**RE: Proposed Strategic Housing Development
Lands at Stradbroke Road, Mountashon, Blackrock, Co Dublin
Independent Stormwater Report Audit**

STORMWATER AUDIT (STAGE 1)

JBA Project Code 2022s0769
Contract Stradbroke Road SHD, Mountashton, Blackrock Co. Dublin
Client Tetrarch Residential Limited
Prepared by Chris Wason
Subject Stormwater Audit Stage 1 Report

Figure 1 - Drainage Layout and SuDS Proposals

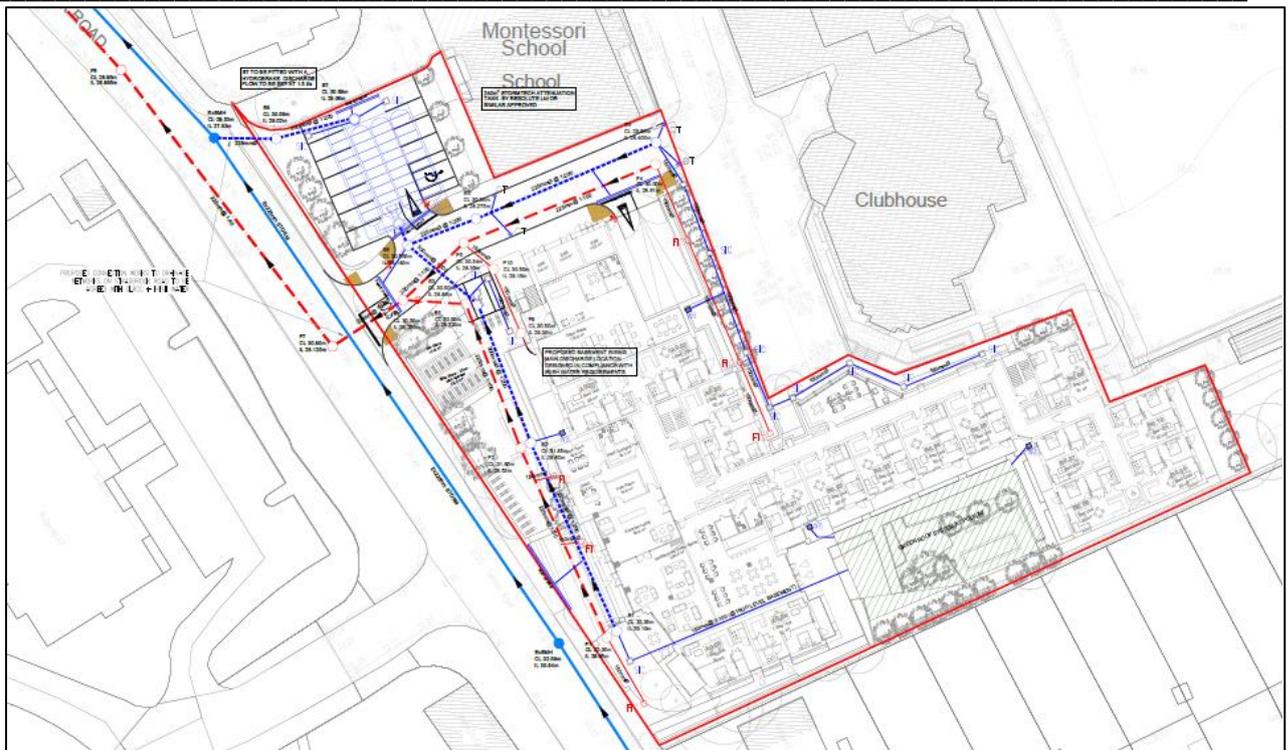
The drainage drg 0003/P03 shows the connectivity of the SW network. It shows gullies and channels located on the road, which is comprised of porous asphalt. It is not clear how this system is supposed to work as no details of the make-up of the porous asphalt and permeable pavement are provided and how these systems are connected back into the SW network.

Details of the permeable paving and porous asphalt should be provided to show how runoff is collected into the sw network and clarify the use of road gullies and Aco channels.

FFL of the buildings should be provided to ensure 500mm clearance during the 100-year storm event.

The impermeable area used in the model and that shown on drg 0013/P02 are different and need to be clarified. If areas have been modified for different surfaces should the default values in the Windes model be changed to 1?
